VALUE ENGINEERING REPORT

**SR 67 Widening
Bulloch County
STP00-0149-01(030), PI No. 522460**

February 2, 2012

Idea No.: A-9
Client: GDOT
Sheet 2 of 6

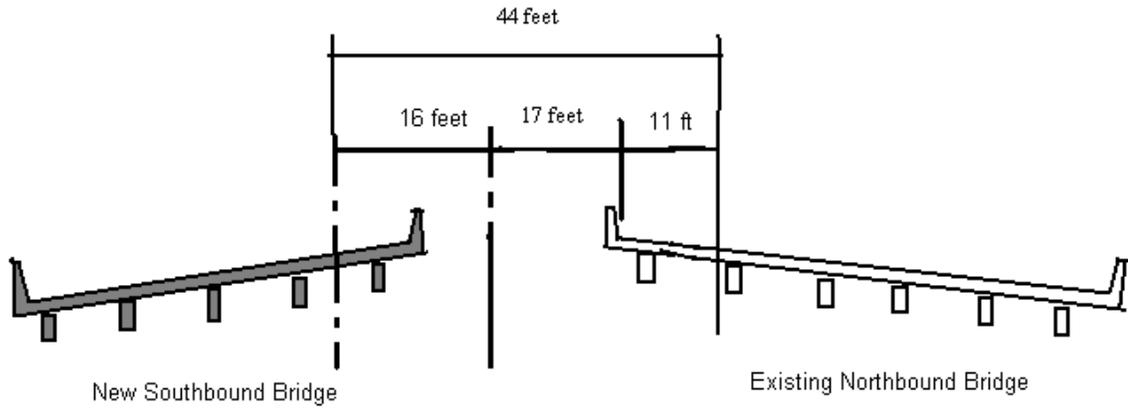
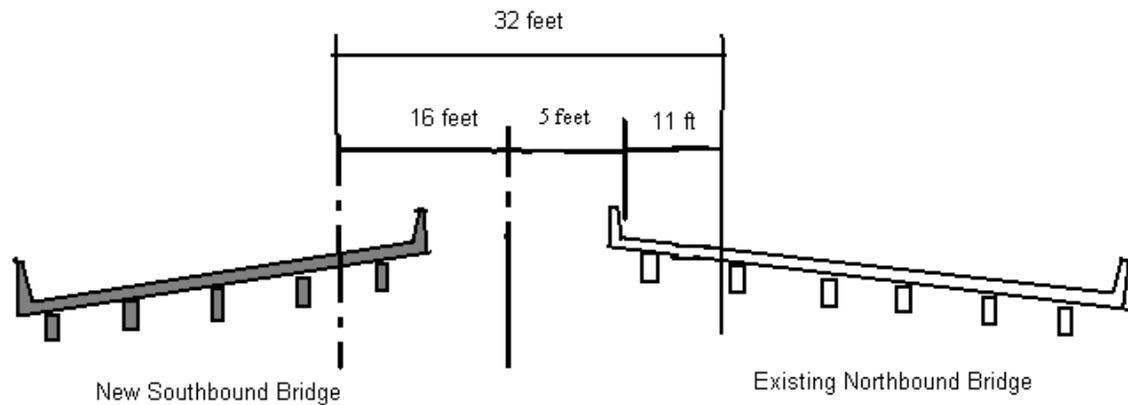
CREATIVE IDEA: Shift the new SB bridge closer to the existing bridge and reduce the median width from 44 feet to 32 feet (Station 330 / Woodcock Branch)

Original Concept: Original concept calls for separate bridges across Woodcock Branch. The existing bridge was constructed in 2001 at an offset from the existing roadbed in anticipation of route being up-graded to a divided 4-lane highway. The existing bridge will carry the NB lanes and a new bridge will be constructed to carry the SB lanes along the old roadbed near the bridge. The proposed SB bridge is 35 feet wide from gutterline to gutterline and is set at a 68-foot offset (bridge centerlines) providing room for a 44-foot median.

The current design uses a 32-foot median for the 4-lane sections except for the area where the dual bridges (also the triple box culvert at Station 391+50) will be constructed. This area incorporates a 44-foot median requiring a transition to and from the 32-foot standard offset before and after the bridge.

This recommendation would shift construction of the new SB bridge and associated roadway to create a 32-foot wide median.

Changing from a 44-foot median to a 32-foot median maintains consistency of typical section with the major portions of the rest of the project. Reducing the median width to 32 feet will make it easier to transition from the 5-lane roadway section at Station 343. Shifting the bridges closer together will reduce the amount of earthwork required to construct the new SB bridge approach sections. Also, the existing pavement structure through this area will require reconstruction because the new roadway profile is higher than the existing profile.

Idea No.: A-9
Client: GDOT
Sheet 4 of 6

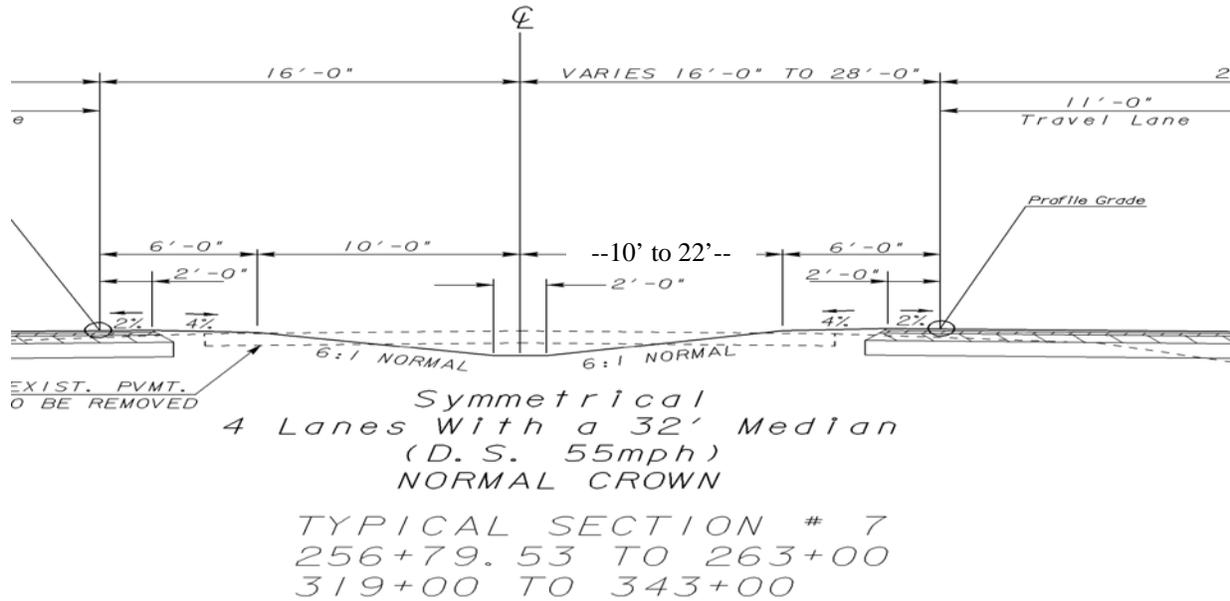
The PGL's for north and south bound will shift in from 44 feet to 32 feet.

The entire transition happens by shifting the new SB alignment toward the NB alignment.

So, the length of the transition = $14 \text{ ft} \times 55 \text{ mph} = 770 \text{ ft}$

Transition Length is OK ($>770 \text{ ft}$)

Transition Length is OK ($>770 \text{ ft}$)

Idea No.: A-9
 Client: GDOT
 Sheet 5 of 6

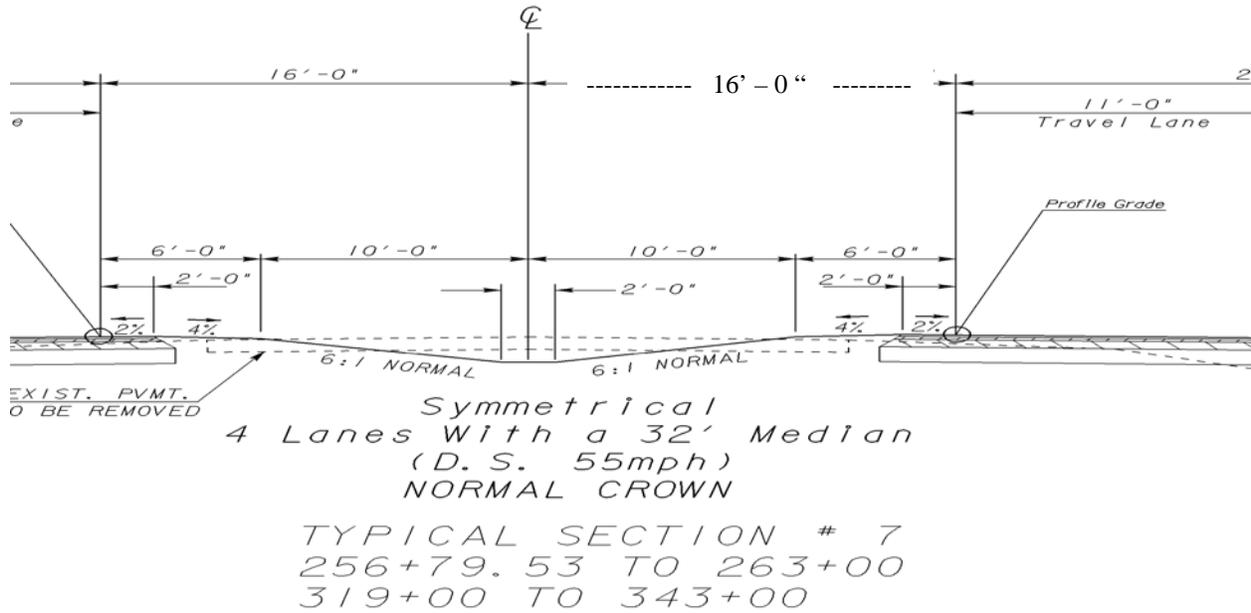
Original Design: SB Shoulder Varies from 16 – 28 Feet

VE Design: SB Shoulder Set at 16 Feet

Idea No.: A-9
Client: GDOT
Sheet 6 of 6

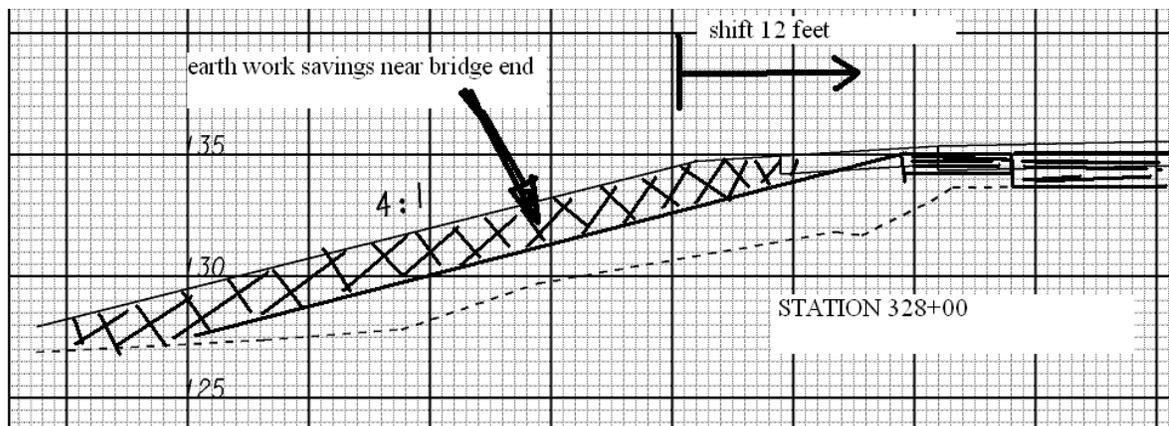
At the bridge, the savings is a 12-foot reduction in width on a 4:1 outside slope for the SB alignment.

Original Cross-section near bridge end

Proposed Cross-section near bridge end

$$(12 \text{ horizontal feet} \times \sim 8 \text{ feet tall} / 2 \times 998 \text{ ft from start of bridge}) + \\ (12 \text{ horizontal feet} \times \sim 8 \text{ feet tall} / 2 \times 1,242 \text{ ft from end of bridge}) / 27 = 3,982 \text{ CY}$$

Idea No.: A-10
Client: GDOT
Sheet 2 of 3

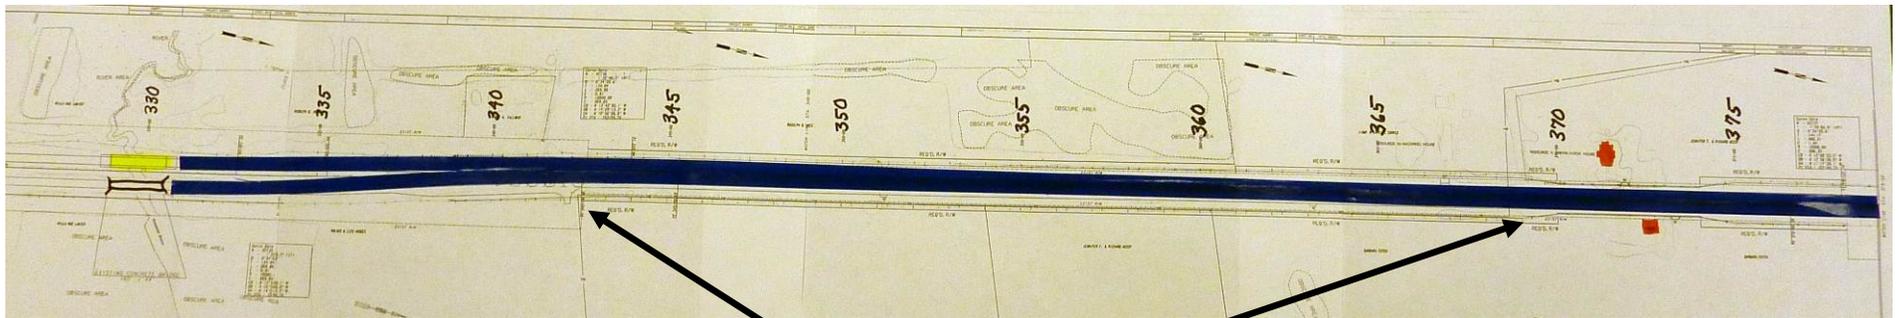
**VE Concept: Keep 5-Lane Roadway & Shift Alignment West
Station 335 to Station 370**

Reduce / Eliminate Impacts to Historic Property
Station 343 to Station 370

This recommendation would keep the original 5-lane roadway and shift its alignment to the west through Stations 343 – 370 to eliminate the need to acquire the 20-foot strip of land from the Historic area.

Idea No.: A-10.1
Client: GDOT
Sheet 2 of 4

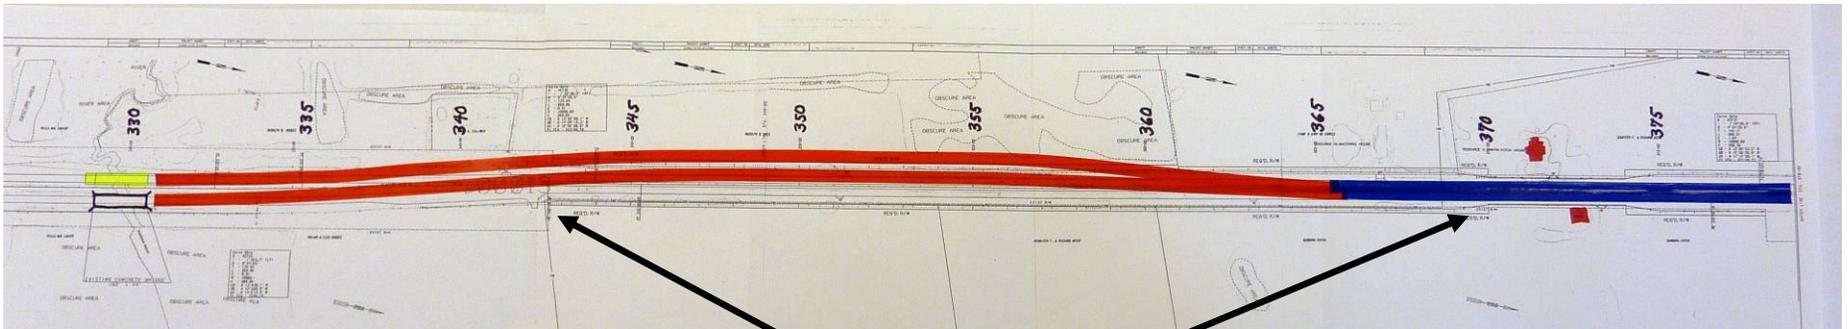
**VE Concept: Continue 4-Lane Roadway & Shift Alignment West
Station 335 to Station 370**

Reduce / Eliminate Impacts to Historic Property
Station 343 to Station 370

This recommendation would continue the 4-lane divided roadway and shift its alignment to the west through Stations 343 – 370 to eliminate the need to acquire the 20-foot strip of land from the Historic area.

Idea No.: B-10
 Client: GDOT
 Sheet 2 of 4

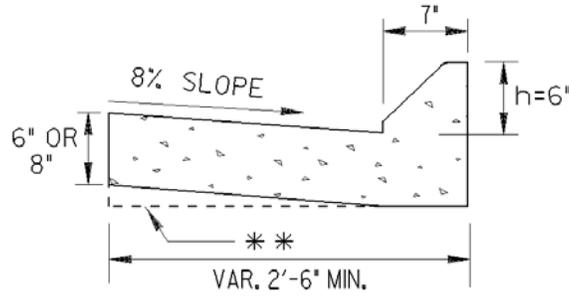
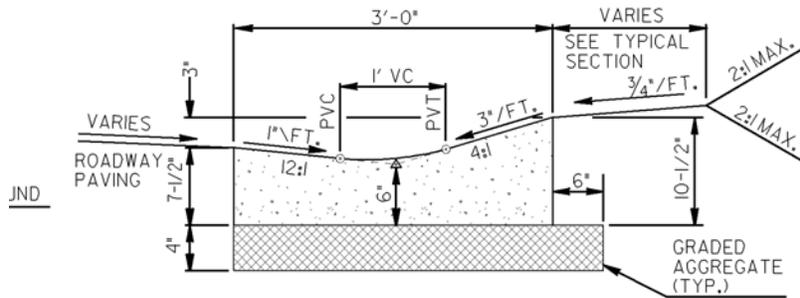
Typical section number 9 incorporates the use of curb and gutter to minimize impacts to the historic properties from Sta. 370+00 to Sta. 374+00. The type of curb and gutter was not identified on the typical section. For purposes of this report, it is assumed to be 8" × 30", Type 7 curb and gutter.

This recommendation would change the curb and gutter type to use V-gutter (Detail D-33) in lieu of the curb and gutter.

Section 6.9 of the GDOT Design Policy Manual states “The AASHTO Green Book states that vertical curbs should not be used along freeways or other high-speed (i.e., > 45mph) roadways, but if a curb is needed, it should be of the sloping type. Where used for pavement drainage or to intercept runoff from the roadside, V-gutter (with appropriately spaced inlets) is preferred over sloped curb.”
